**RE: SUBMISSION TO SSD-79261463 FOR RESIDENTIAL FLAT BUILDING WITH INFILL
AFFORDABLE HOUSING AT 2-4 WOODSIDE AVENUE & 1-3 REID STREET, LINDFIELD**

Ku-ring-gai Council's objection to SSD-79261463 at 2-4 Woodside Avenue & 1-3 Reid Street, Lindfield

Figure 1: Proposed land use zone map

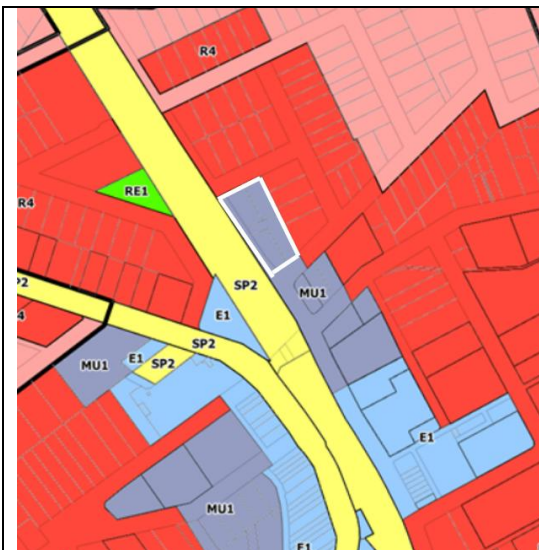
- rezone the subject site from R2 Low Density Residential to MU1 Mixed Use (**Figure 1**)
- increase the height of building (HOB) from 9.5m to 29m (**Figure 2**)
- increase the FSR ratio from 0.3:1 to 3:1 (**Figure 3**)
- apply the active street frontage clause (6.4 of KLEP) to the Woodside Avenue street frontage and a portion of Lindfield Avenue street frontage (as shown in red on **Figure 4**)

Figure 6: 8th storey – required setback is 9m

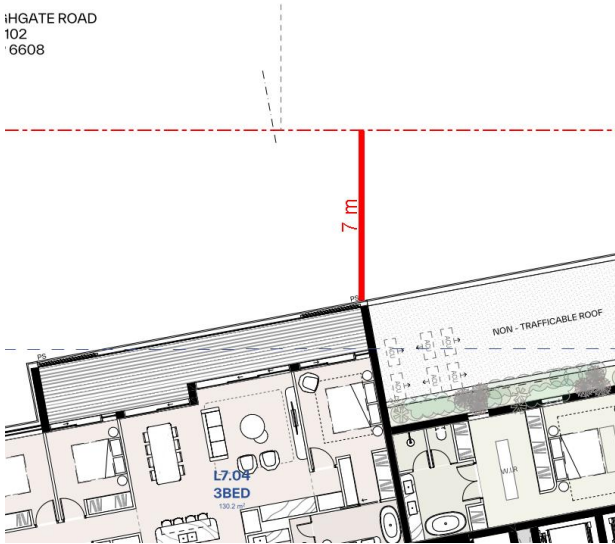
Council is particularly concerned with the proposed setback of the building from the rear boundary. Part 3F of the ADG requires habitable rooms and balconies the following setbacks from the rear boundary:

- 6m (up to 12m / 4 storeys)
- 9m (up to 25m / 5-8 storeys)
- 12m (up to 25m / 9 storeys).

Numerous apartments do not comply with the required setback. Non-compliances have been identified on all levels. Some examples of the non-compliances are shown below:

The proposed non-compliant building separation will result in poor outlook, and visual and acoustic amenity impacts, particularly given a large residential flat building (RFB) is also proposed on the adjoining site (SSD-78493518). The substantial non-compliance with the ADG design requirement is completely unacceptable.

- Reduce the FSR to an amount which allows for fully compliant 6m setbacks (including basement) from the street frontages and ADG compliant setbacks from the rear boundary (as specified in Part 3F). This could be potentially achieved by reducing the depth of the building.
- Provide a minimum setback of 2.4m of the top storey from the outer face of the floors below on all sides in accordance with Part 7C.8 of KDCP.
- Reduce the building height to comply with the maximum permitted height.
- Provide a compliant amount of deep soil (Refer to Section F 'Landscaping and Tree Impacts').

Figure 8: Centre apartments with non-compliant depth (repeated layout from ground level to Level 7)

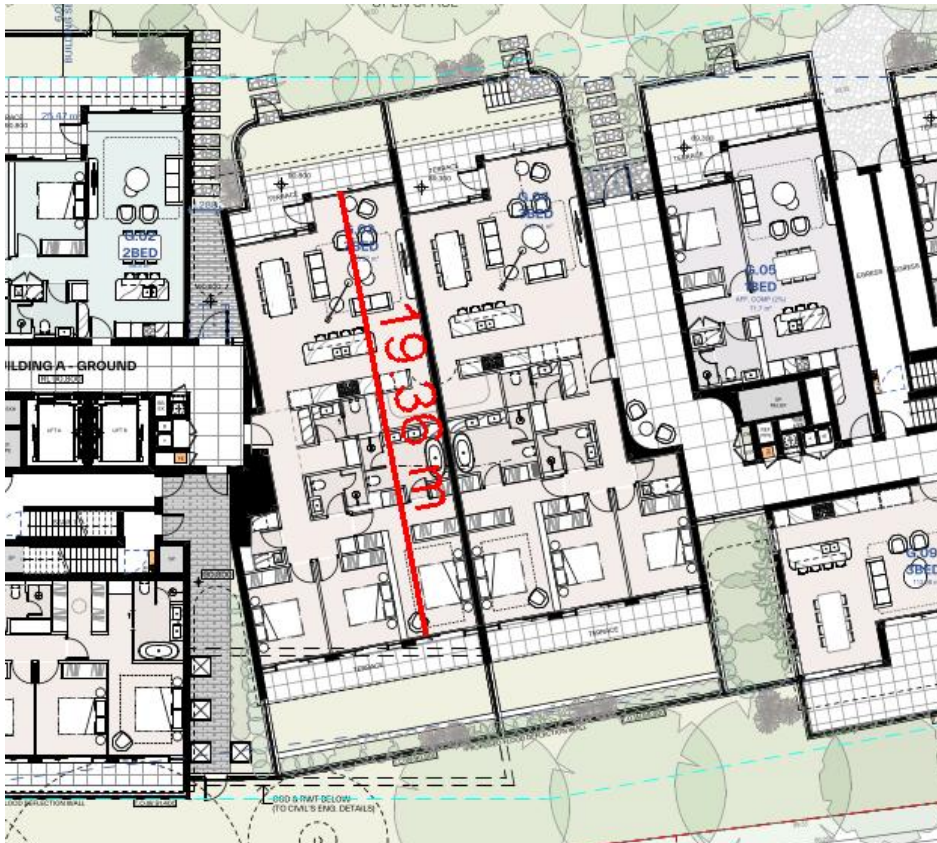
Furthermore, the design of the building results in the apartments in the middle of the building having a depth of approximately 19.36m which exceeds the maximum apartment depth of 12-18m recommended in Part 2E of the ADG:
